EASTERN REGIONAL POWER COMMITTEE

MINUTES OF 20th PROTECTION SUB-COMMITTEE MEETING HELD AT ERPC, KOLKATA ON 19.06.2014 (THURSDAY) AT 11:00 HOURS

- B.1.1: BIHAR System.
- i. Disturbance at 132 kV Purnea (BSEB) S/S on 27/04/14, 01/05/14, 16/05/14.

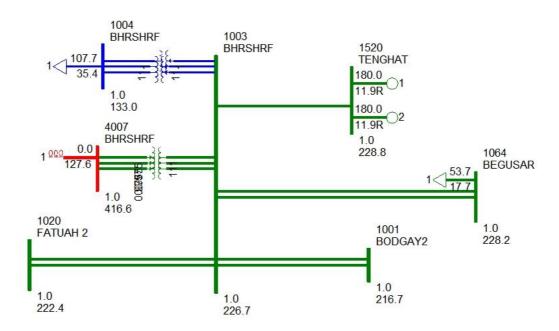
After detailed deliberation, it was opined that all the three incidences the fault clearance time was much higher than the CEA standard. Therefore, the PCC advised the following actions to BSPTCL:

- 1) Proper co-ordination & grading of over current relays for 33 kV feeders
- 2) Co-ordination of over current relays timings of 132/33 kV ICTs with 33 kV feeders
- 3) Checking of operating time of all CBs at Purnea & its downstream systems and rectifying / replacing the faulty CBs, if any.

PCC advised BSPTCL to complete the above actions within 10 days and submit a report to ERPC Secretariat at the earliest. BSPTCL agreed.

ii. Tripping of 220 kV Biharshariff- Tenughat on 27/04/14.

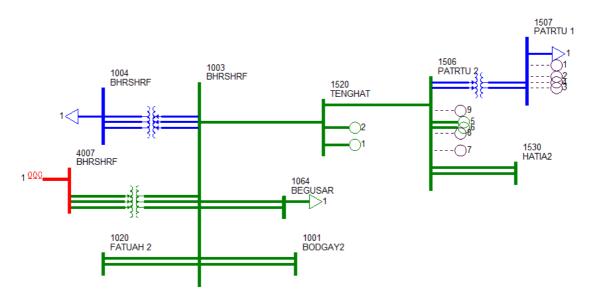
<u>Analysis</u>: From the preliminary report it appears that BSPTCL attempted to charge the 220 kV Biharshariff- Tenughat line from Biharshariff end without clearing the fault. As the fault was permanent in nature the line could not hold and it got tripped. However, the tripping of 400/220 kV ICTs and 220 kV D/C Biharshariff- Fatuah at Biharshariff needs to be explained.

BSPTCL may elaborate the findings of the faults and tripping details of ICTs and 220 kV Biharshariff- Fatuah D/C line.

BSPHCL informed that they had observed pole discrepancy at Biharshariff end, so the charging attempt was made through bus coupler CB. Since the line remained faulty, as a result 400/220 kV ICTs and 220 kV D/C Biharshariff- Fatuah got tripped from Fatua end.

PCC advised BSPTCL, TVNL & JSEB to co-ordinate before charging the 220 kV Biharshariff-Tenughat line. Prior to charging such an important line, patrolling should be carried out jointly as decided in 27th TCC/ERPC meeting.

Further, BSPTCL was advised to check the operating time of all CBs at Biharshariff & Fatua along with Purnea S/s and submit a report to ERPC Secretariat.

Disturbance at Tenughat/ Patratu/Hatia (JSEB) on 03/05/14 & 31/05/14.

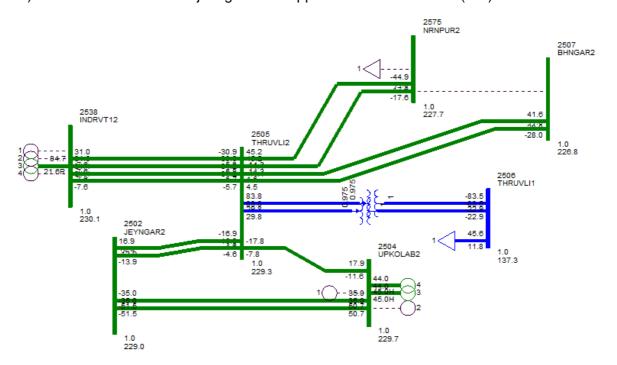
Analysis: As per preliminary report both the days due to inclement weather conditions the 220 kV Tenughat-Patratu, 220 kV Patratu- Hatia and 132 kV Patratu- Hatia were tripped along with Tenughat and PTPS units.

JSEB may elaborate with relay indications obtained.

PCC advised ERPC Secretariat to take up the issue with JSEB for proper representation in the meeting and also to ask the detail report of the disturbances.

However, from the ERLDC report it appeared that the there was problem in Patratu end. PCC advised for testing of Patratu end relays and circuit breakers and report.

- i. Tripping of all feeders from 220 kV Theruvali S/s on 25.04.14.
- > 220 kV Theruvali- Narendrapur I was tripped on 25/04/14 due to earth wire snapping Minutes of 20th PCC meeting

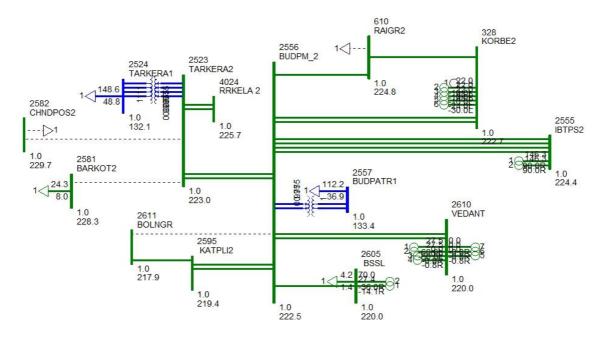
<u>Analysis</u>: As per the report there was fault in 220 kV Theruvali- Narendrapur – I line due to earth wire snapping which fell on R-Ph conductor. The main breaker of 220 kV Theruvali-Narendrapur - I at Theruvali end failed to clear the fault and as a result ICTs along with all feeders emanating from Theruvali S/s got tripped. Following points need to be addressed:

- i) Non-tripping of Breaker of 220 kV Theruvali Narendrapur- I at Theruvali end.
- ii) OPTCL may give the latest status of replacement of defective CBs at Theruvali S/S.
- iii) Tripping of 220 kV feeders at Sl. No. 2, 4, 5 from remote end only.

OPTCL informed that, the distance relay of 220 kV Theruvali – Narendrapur- I at Theruvali end was kept out of service for replacement of numerical relays and master trip relay was in defective state. Hence the fault was not cleared from Theruvali end. As the fault persisted all other lines connected to Theruvali 220 kV substation were tripped from remote ends on non-directional over current & earth fault relays.

For remedial measures, OPTCL informed that new DP relay Numerical (SEL-311C) was commissioned in 220kV Therubali –Narendrapur feeder-I on 26.05.2014. Action is also being taken to replace electromagnetic non-directional over current & earth fault relays with numerical relays at there.

PCC advised all the constituents to take the line under shutdown in case of replacement of numerical relays unless two master trip relays are available, so as to avoid such total power failure in a substation.

ii. Tripping of 220 kV Tarkera-Budhipadar- I & II on 13/05/14.

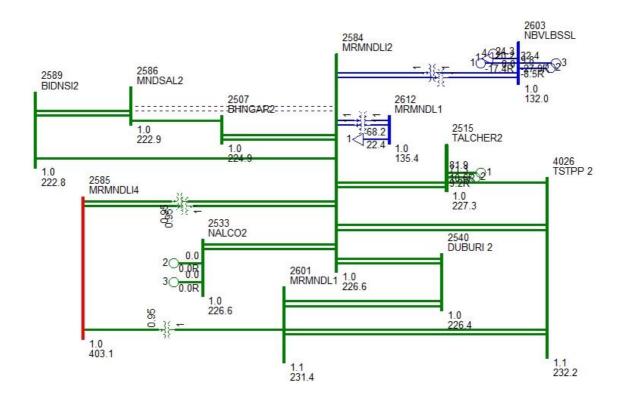
- **A.** Tripping of 220kV Budhipadar-Tarkera-I at Tarkera at 21:42hrs due to damage of R-Ø CT and Y-Ø LA at Tarkera end. The Budhipadar end CB did not trip and Budhipadar-Tarkera-II tripped from Budhipadar end on R-Ø, Z-II which needs to be explained.

- **B.** At 21:43 Hrs, bus fault occurred at Budhipadar due to bursting of Y-Ø Main Bus-II post insulator of 220kV Budhipadar-Tarkera-I at Budhipadar. The bus differential protection at Budhipadar did not operate, due to which all the lines connected to Budhipadar tripped from remote end only. And due to loss of evacuation path units of IbTPS, Burla, Chipilima & other IPPs also got tripped. The following points need to be addressed:

- i) Non-tripping of Budhipadar end Breaker of 220kV Budhipadar-Tarkera-I line in first incident.
 - ii) Tripping of Budhipadar-Tarkera- II from Budhipadar end on R-Ø, Z-II in first incident.

- iii) In second incident, the non-operation of bus-bar protection scheme at Budhipadar S/s.

OPTCL explained with a presentation on above incidence that, 220kV Budhipadar-Tarkera – I feeder was in Transfer bus coupler (TBC) but breaker did not operate. This might have been due to defect in "Trip Transfer switch". Further, no back up of protection was available in TBC feeder.

OPTCL informed that, provision for annunciation to indicate improper functioning of Trip Transfer switch is being arranged. Provision for back up protection of TBC is also being arranged.

RADSS (ABB make) Bus bar protection system of Budhipadar 220 kV S/s was in defective state. New Bus bar protection system already received and installation & commissioning is in process. Expected time of completion is six months.
